# Technical Bulletin

Bulletin No: TCH-001-051

## Subject: **BA-921 COMPRESSOR UNLOADER CAP REPLACEMENT KIT**

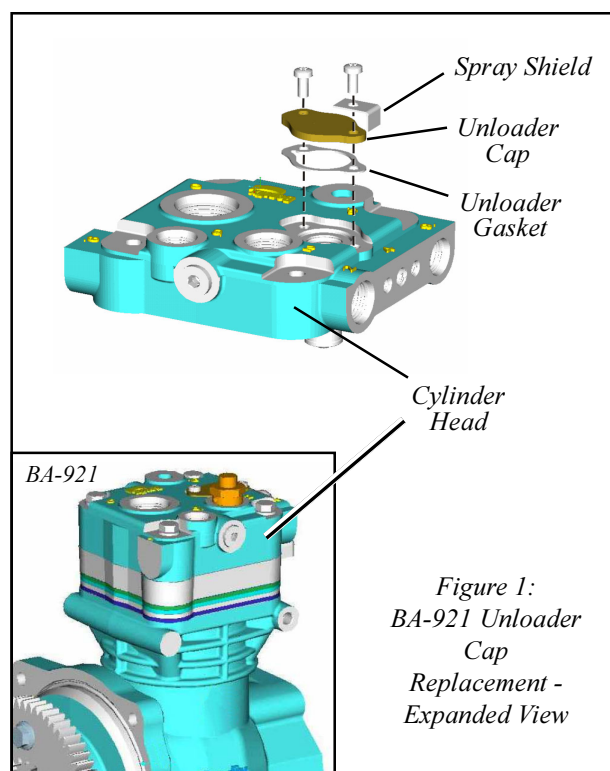
Bendix Commercial Vehicle Systems has determined that for some\* BA-921 air compressors, under certain conditions, air pressure can collect above the unloader piston. This prevents the compressor from return to the unloaded mode, causing it to constantly build air. Bendix has determined that this condition is not safety related.

To guard against this occurring, Bendix has developed a replacement unloader cap designed to prevent air being retained above the unloader piston. Bendix recommends that all BA-921 air compressors listed at the bottom of this page have the replacement unloader cap kit installed.

Detroit Diesel Corp. and Caterpillar Inc. will be conducting a service campaign where authorized DDC and CAT service centers will offer unloader cap replacement kits. The kits, Bendix part number 5012771, contain an unloader cap, unloader gasket and spray shield (see Figure 1) along with installation instructions. Replacement should take less than 20 minutes to complete.

Where a **spray shield** is already installed, the unloader cap upgrade has already been made, and **no action is needed**. Only the BA-921 compressors listed below are part of this service campaign.
